1975 - FEDERAL
OSHA - PEDRICKTOWN

To	A.R. Webber	From	J.M. Smith	RECEIVED
Location	Pedricktown	Location	Pedricktown	JUL 29 1975
Department		Department		R. A. KELLEY
Subject	O.S.H.A. PRELIMINARY SURVEY			Date 7-21-75

VELOMETER READINGS OBTAINED IN MASS RESIN, BUILDING 512

MASS BUILDING VENTILATION

BUILDING 512 - MASS RESIN

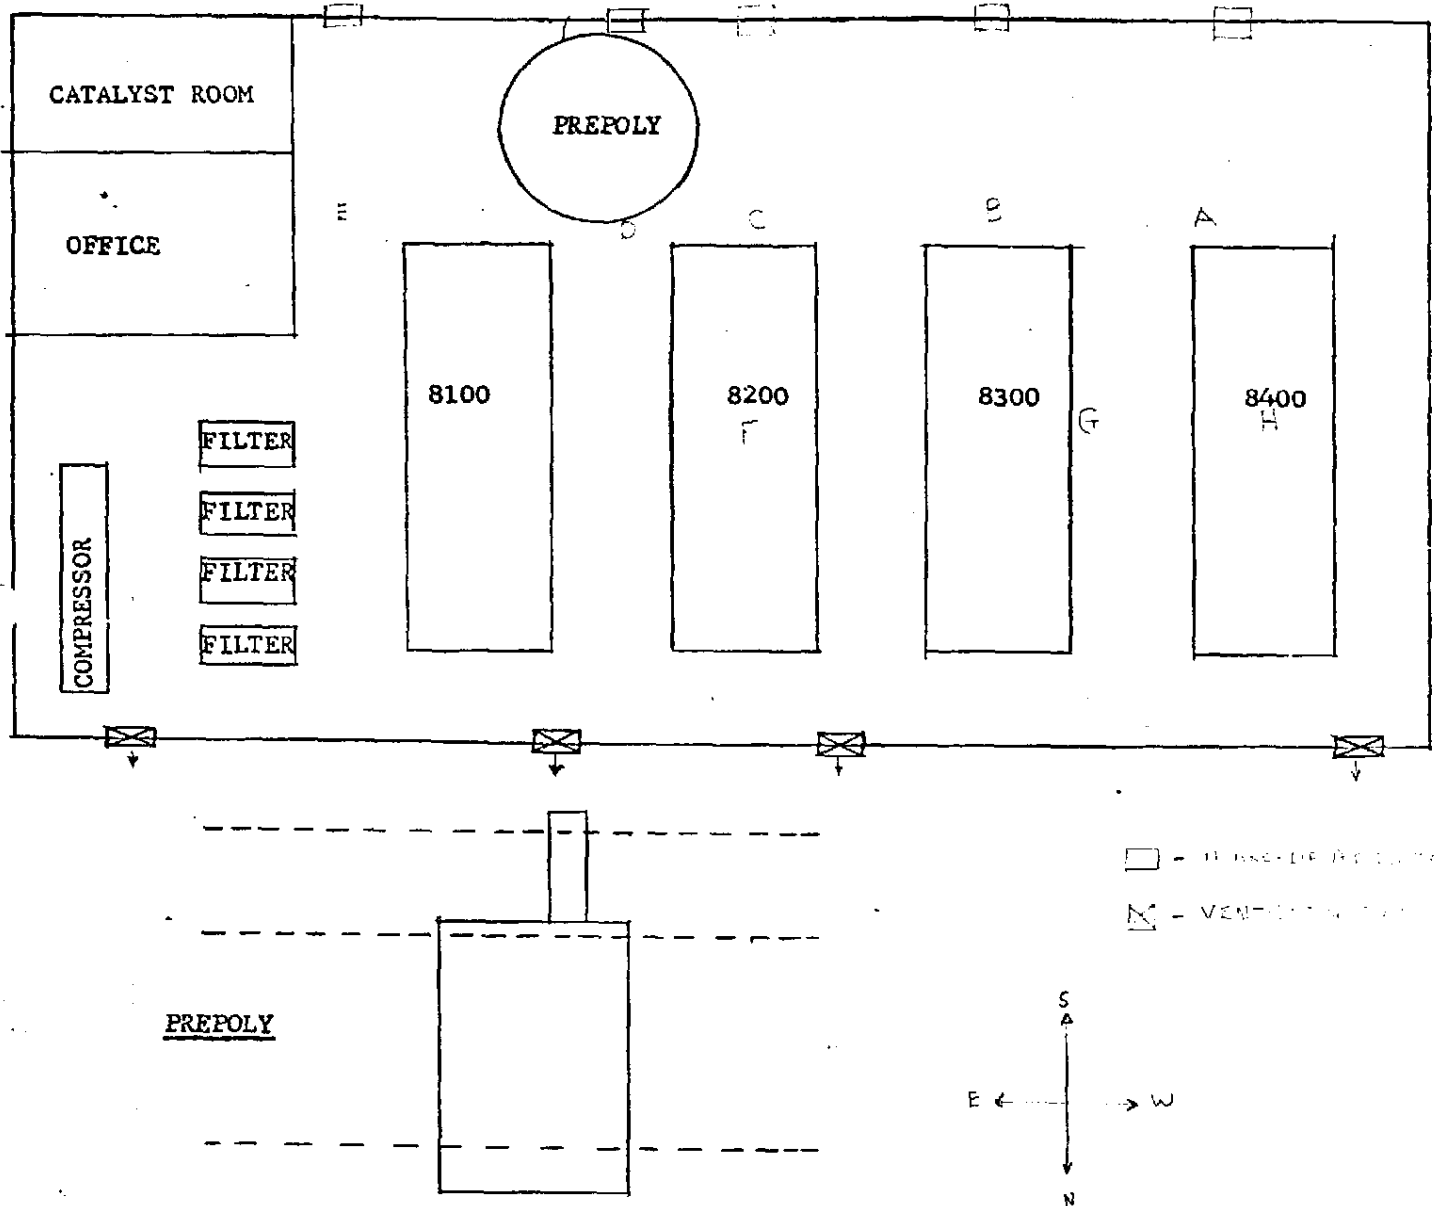
The velometer results obtained by Mr. Abraham Hyman, OSHA Industrial Hygienist, are reviewed below.

<u>Sample Point</u>	<u>Reading Obtained</u>
A	500 LFM
B	150-200 LFM
C	0-60 LFM
D	50-200 LFM
E	0-150 LFM
F	0 LFM
G	20 LFM
H	0-125 LFM

The location of each reading is shown on the attached building drawing. Readings A-E were taken on the office level, and readings F-H were taken on the mezzanine above the autoclaves.

FIGURE 1

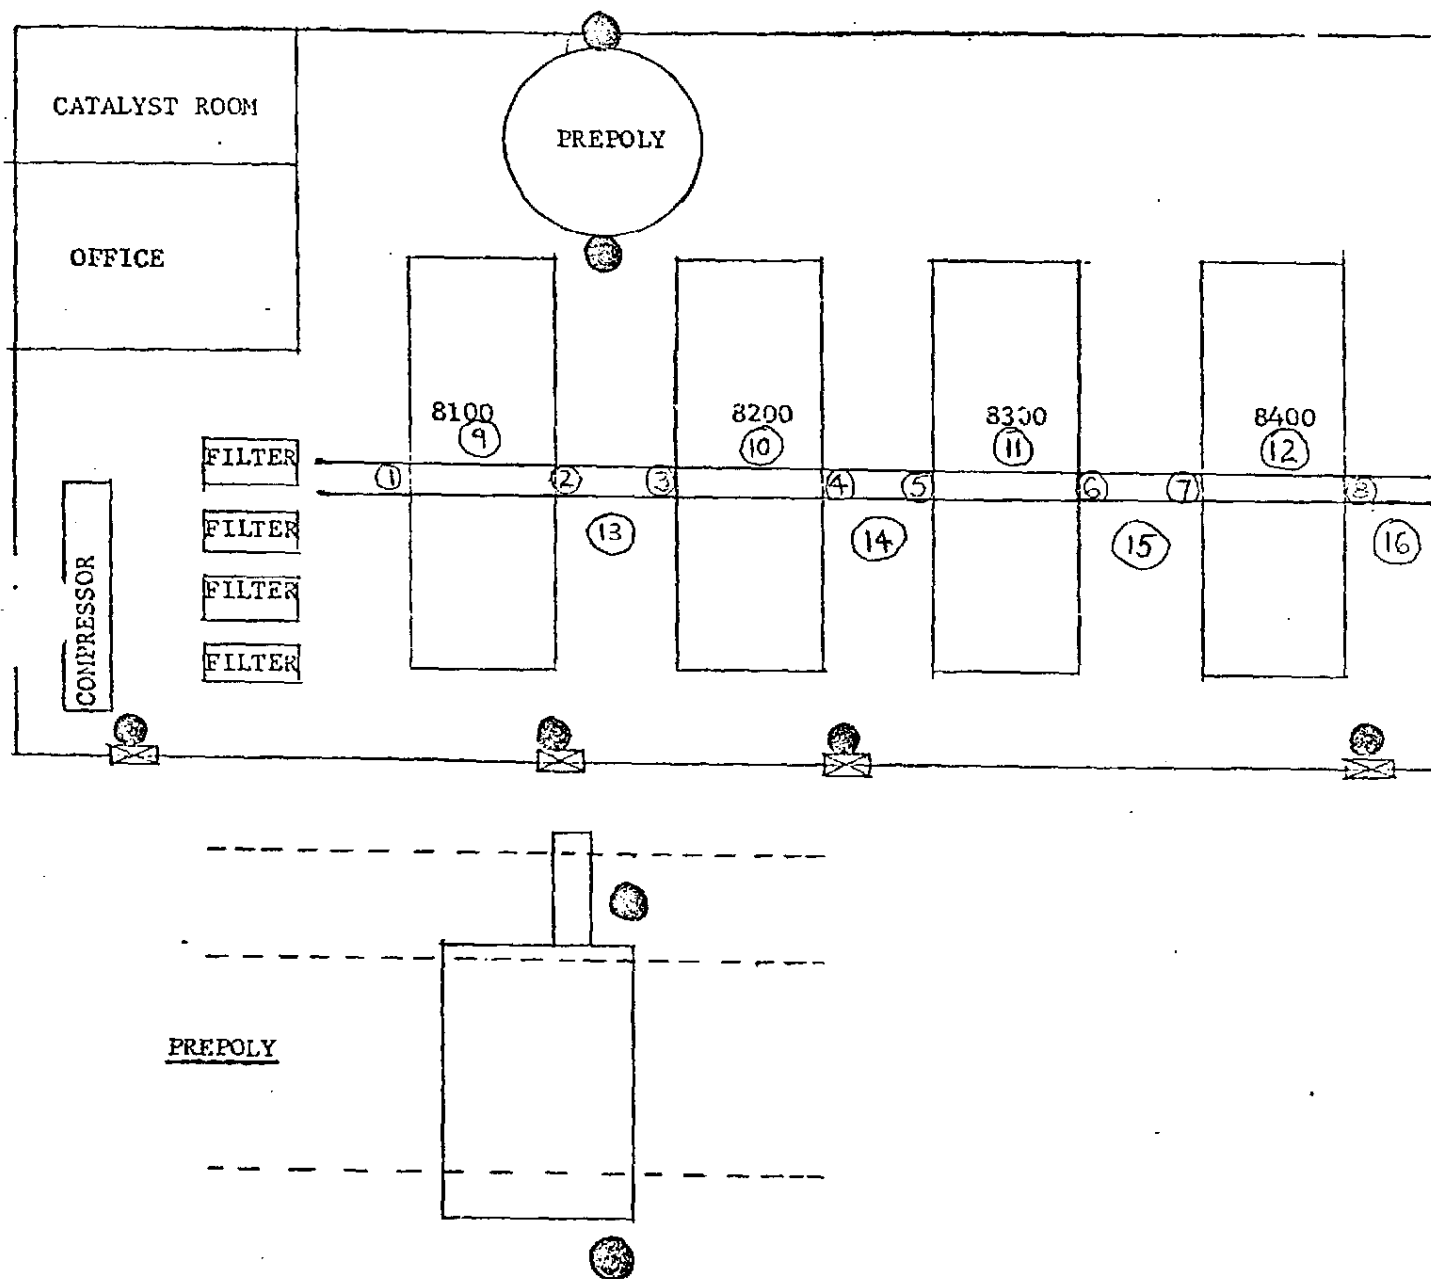
The Mass Building has intake air vent units and forced air units to channel outside air through the building from south to north. Data was collected using different combinations of open vent units. The building sampling points are shown in Figure 1. These locations were selected to give a representative cross section of flow in the building. Sampling points 1 through 8 are on the catwalk level by the top of the autoclave condensers, locations 9 through 12 are on top of the autoclaves, and points 13 through 16 are on the ground floor between the reactors. In all cases the two roof fans were running and the ground level fans were on the emergency, summer position. The prepoly fan facing south was off.

None of the trials showed consistent readings of acceptable air flow rates on the catwalk above 8100 and 8200. However, air flow was slightly bettered with the mezzanine level covered, and 2 of the 4 ground floor fresh air vents closed. On subsequent days readings were taken with all fresh air and forced air vents on the ground floor closed. This combination caused turbulence above 8100 and 8200. Also with just the forced air closed, no increased air flow was observed by the catwalk.

Due to the obstruction caused by the prepoly and its piping, flow patterns are altered by 8100 and 8200. Covering the mezzanine level did not improve these conditions significantly. Because increased air flow into this area would still be altered by the prepoly, a viable alternative is to remove air from the condenser level. This would best be achieved through ductwork to the catwalk from the roof ventilation units.
